## Product Change Notice (PCN)

PCN Number: **PCN-0450881R-01**

Product(s) Affected: **PJ1-022**

| PREVIOUS CUI DEVICES DETAIL / IMAGE |              |         | NEW CUI DEVICES DETAIL / IMAGE |                |                |               |

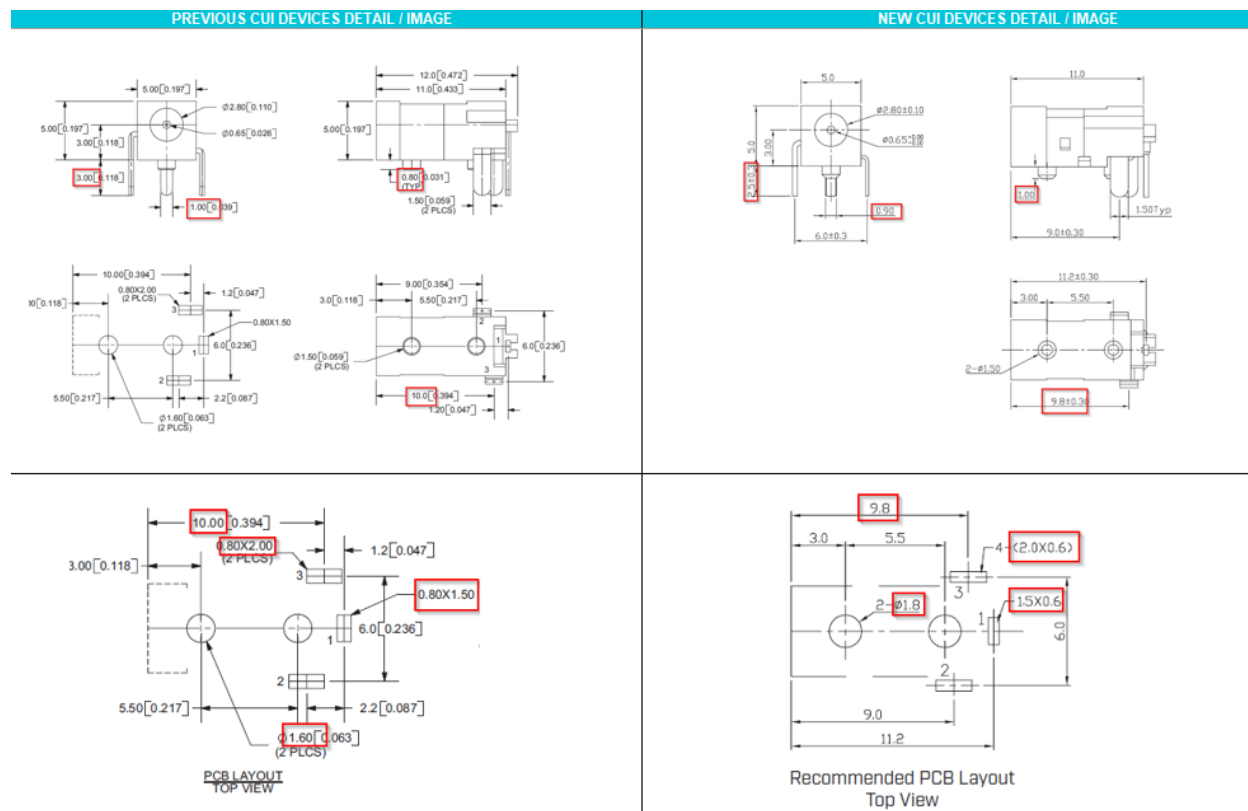
Description of Change: **Minor Housing and footprint differences. Material Change on the housing and terminals. See image Below**

| PREVIOUS CUI DEVICES DETAIL / IMAGE |              |         | NEW CUI DEVICES DETAIL / IMAGE |                |                |               |
|-------------------------------------|--------------|---------|--------------------------------|----------------|----------------|---------------|
| center pin                          | brass        | silver  | center pin                     | brass          | brass          | silver        |
| terminal 1                          | brass        | silver  | terminal 1                     | brass          | brass          | silver        |
| terminal 2                          | copper alloy | silver  | terminal 2                     | Be-Cu t=0.25   | Be-Cu t=0.25   | silver        |
| terminal 3                          | brass        | silver  | terminal 3                     | brass t=0.40   | brass t=0.40   | silver        |
| plastic                             | PA66         |         | housing                        | PA66 (UL94V-0) | PA66 (UL94V-0) | black         |
